FORD E40D "UPDATE HANDBOOK"

INTRODUCTION FORD E4OD "UPDATE HANDBOOK"

**FORD E40D
VALVE BODY, SPACER PLATE, SPACER PLATE GASKETS,
CHECKBALL LOCATIONS, AND CASE CHANGES,
FOR THE 1996 MODEL YEAR**

Figure 78

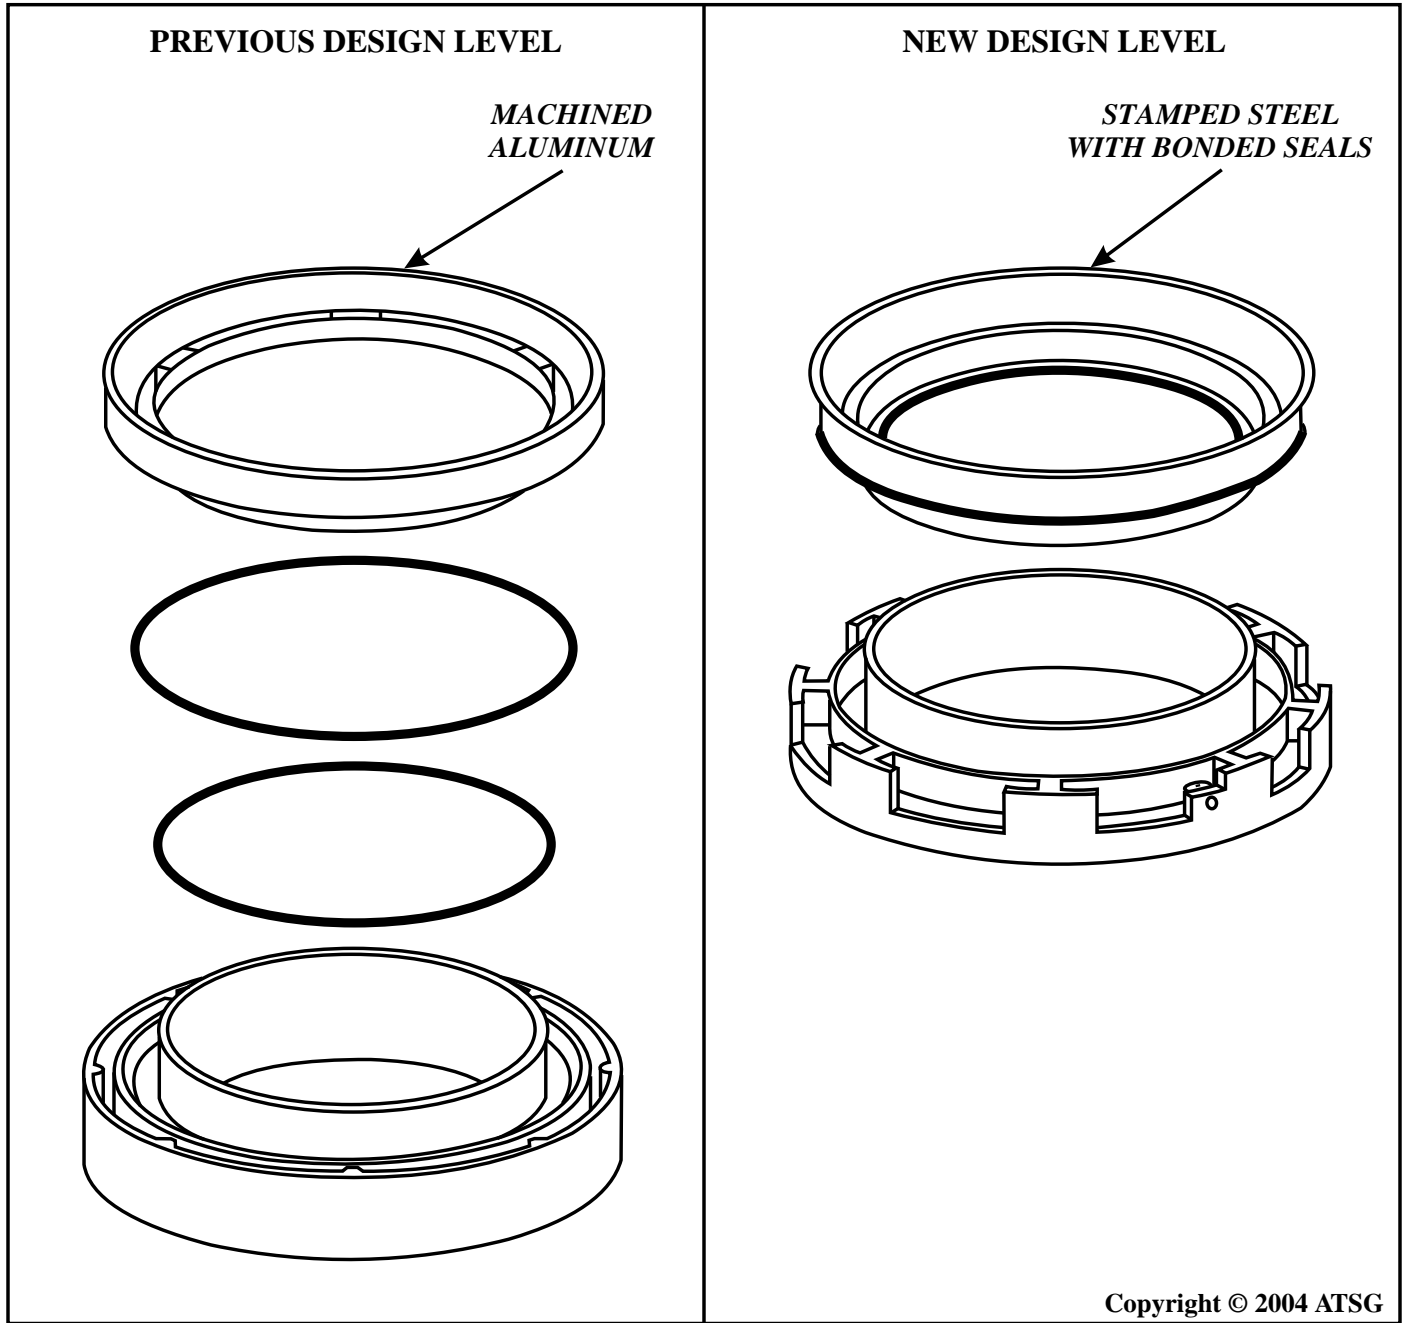
CHANGE: Some 1996-1997 vehicles equipped with the E4OD transmission were built with a new design level overdrive clutch piston, with the seals bonded to the piston (See Figure 78).

- (1) OVERDRIVE PISTON - Now stamped steel with moulded rubber inner and outer seals on the piston assembly, instead of the previous machined aluminum, as shown in Figure 78.
- (2) OVERDRIVE/INTERMEDIATE CLUTCH CYLINDER - Major casting changes to clutch cylinder, to accommodate the new design level bonded piston, as shown in Figure 78.

Figure 79

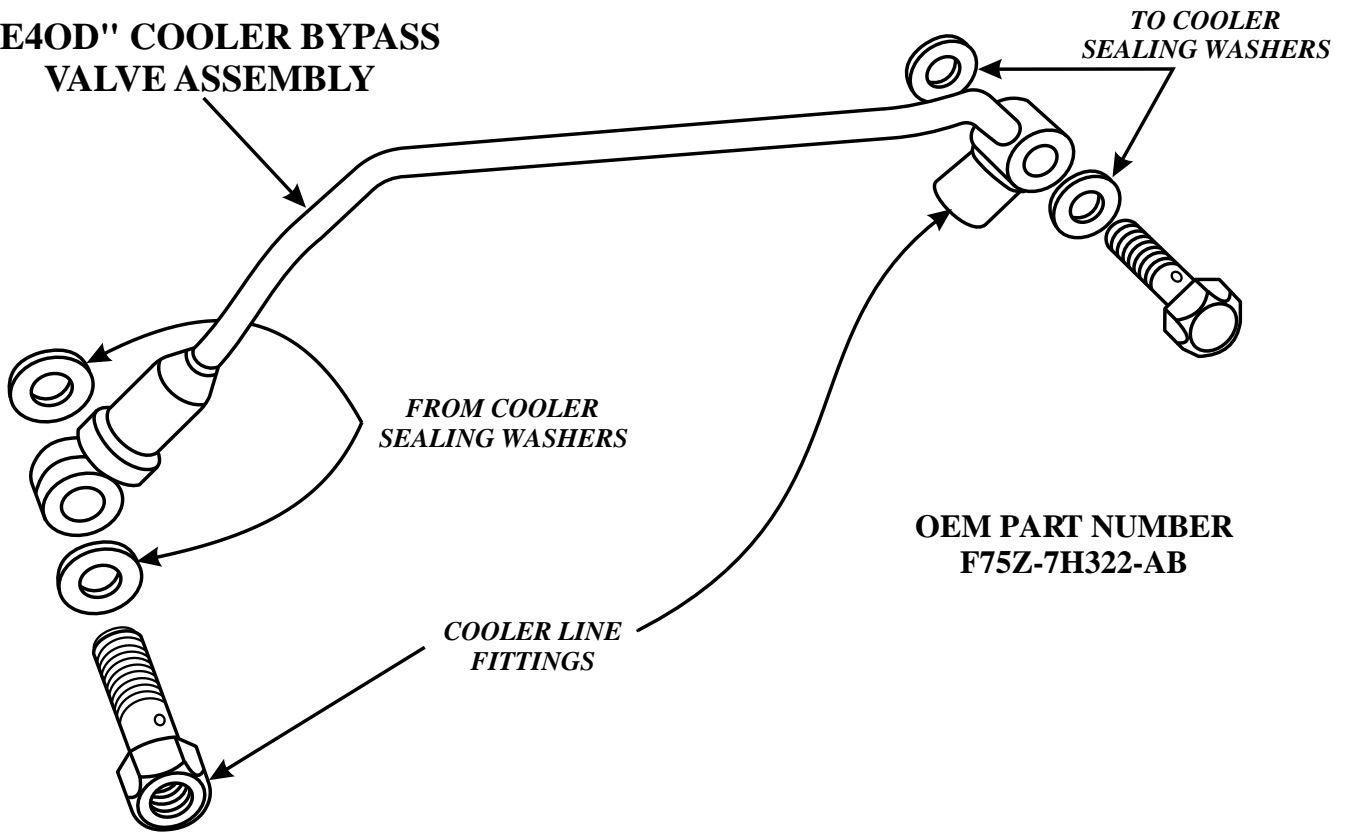
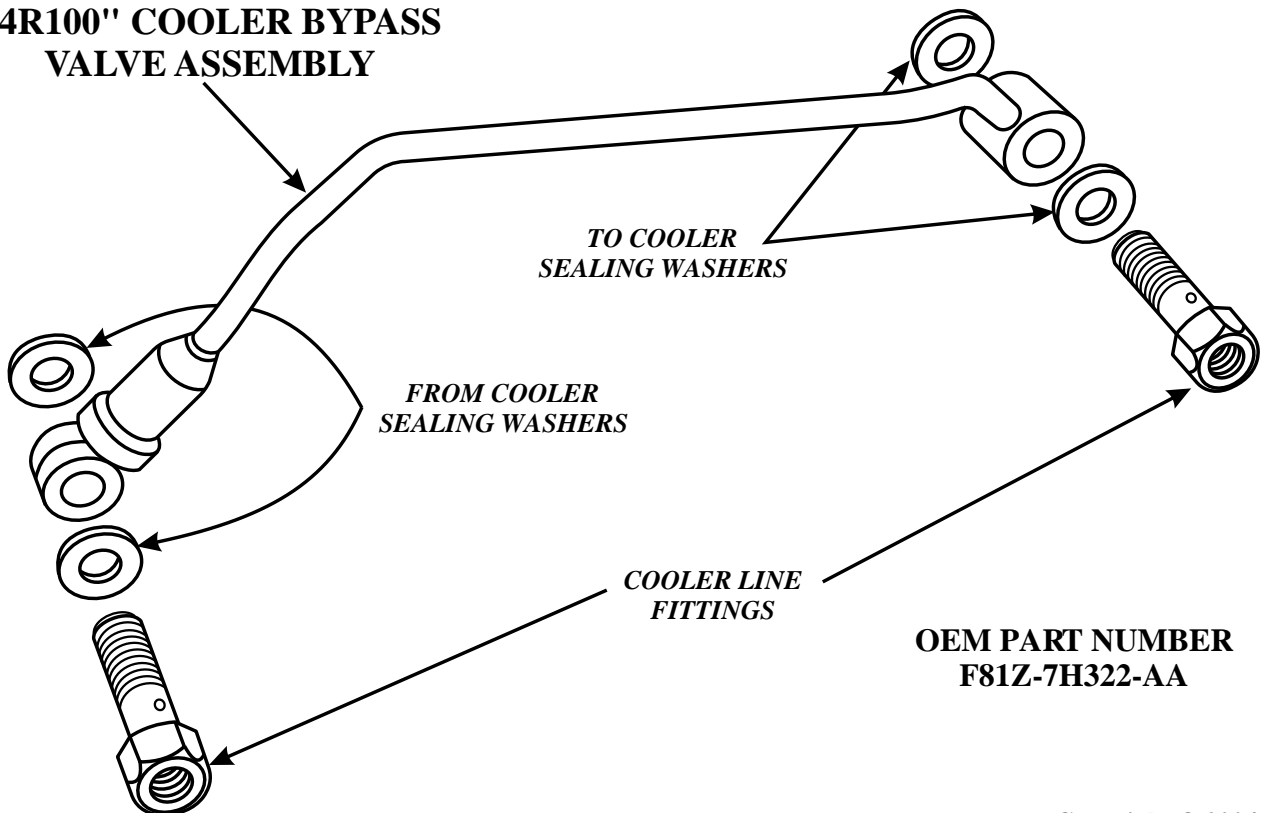
CHANGE: Some 1997 Econoline, Expedition, F-150 Trucks and F-250 Trucks have been equipped with a Cooler Bypass Valve Assembly that requires sealing washers on both the "To Cooler" end and "From Cooler" end of the bypass valve assembly, as shown in Figure 79.

- (1) COOLER BYPASS VALVE ASSEMBLY - Added between the cooler line fittings in the case, to increase lube flow during cold weather operation (See Figure 79).
- (2) CASE FITTINGS - Requires special case fittings to retain the "Banjo" ends of the cooler bypass valve assembly into the transmission case (See Figure 79).
- (3) SEALING WASHERS - Requires sealing washers on both of the "Banjo" ends of the cooler bypass valve to seal properly (See Figure 79).

The new design Cooler Bypass Valve Assembly will retro-fit back to all previous models, and we would recommend the 4R100 style bypass valve assembly, as shown in Figure 79, because you do not have to bend the existing cooler line to get it hooked up.

Figure 80

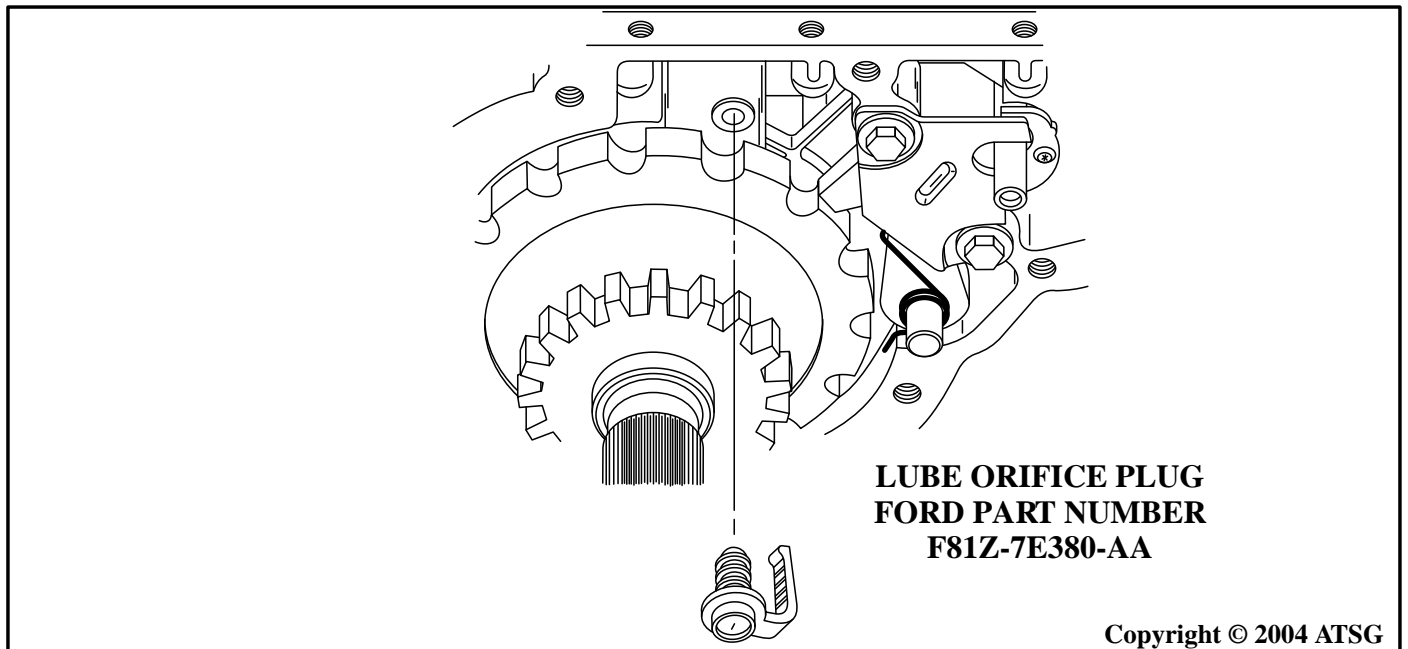
- (1) TRANSMISSION CASE - Added passage at the rear of transmission case to accept the added plastic lube orifice plug, as shown in Figure 80.
- (2) EXTENSION HOUSING - Added cast-in shoulder/boss that retains the added lube orifice plug in the transmission case, as shown in Figure 81.

Figure 82
AUTOMATIC TRANSMISSION SERVICE GROUP

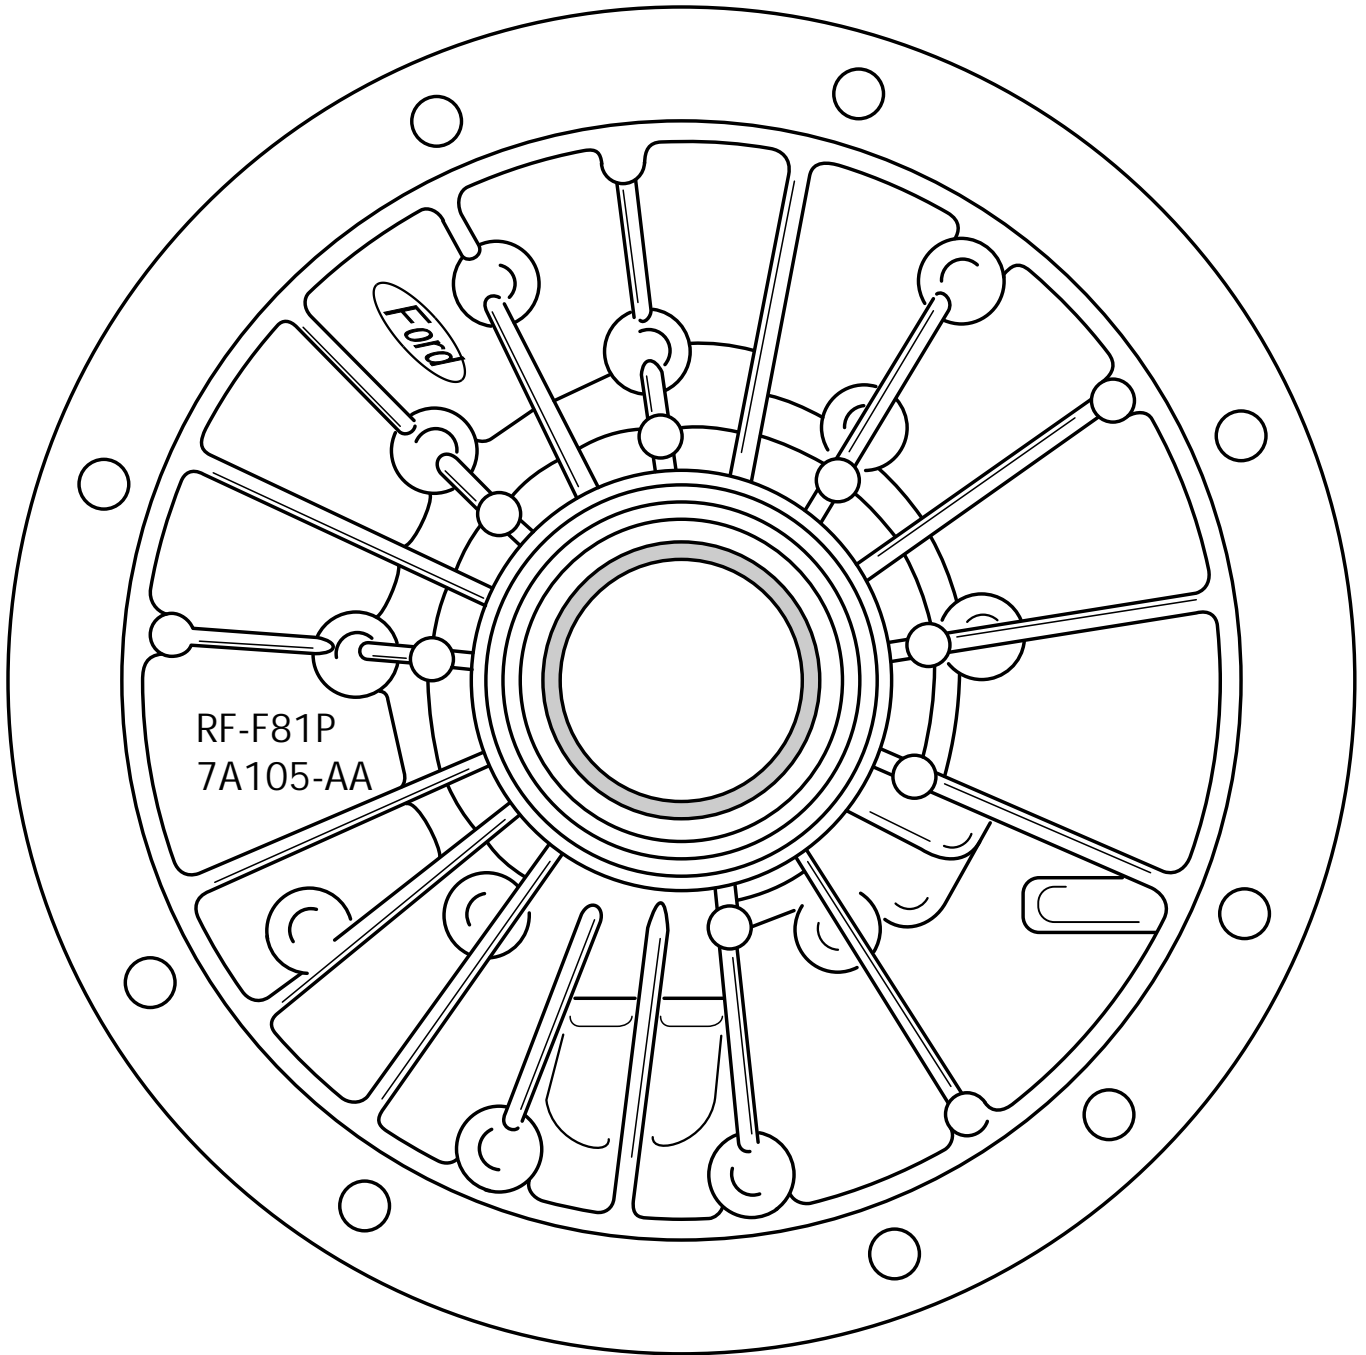
- (1) OIL PUMP BODY - Now has different worm tracks to accommodate the new pump cover assembly and is identified by the rough forging number RF-F81P-7A105-AA, and is cast into the pump body in the location shown in Figure 82. The worm track side of the new pump body and the previous pump body are shown in Figure 83.

FORD E4OD/4R100 VALVE LINE-UPS IN PUMP ASSEMBLY

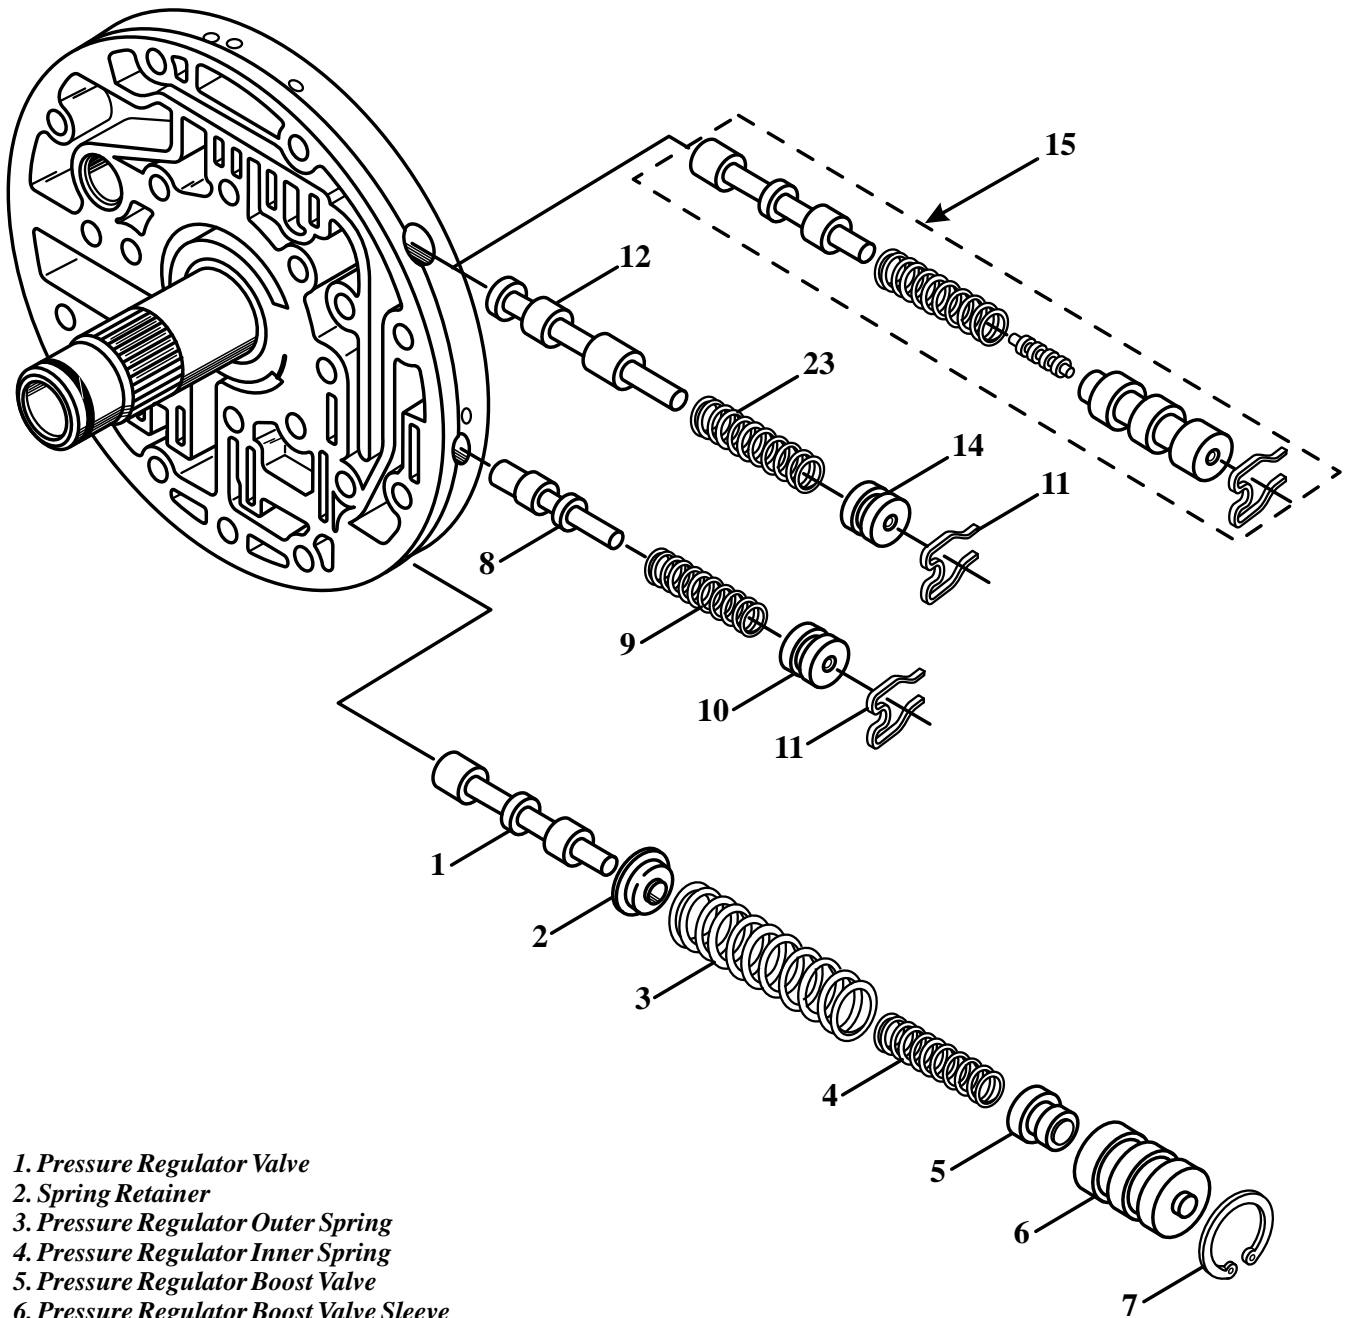
- (3) TCC LINE-UP - There are now two different Converter Clutch Control Valve Line-Ups in the oil pump cover depending on whether it is gasoline or diesel engine. Both of these valve line-ups are illustrated in Figure 85.
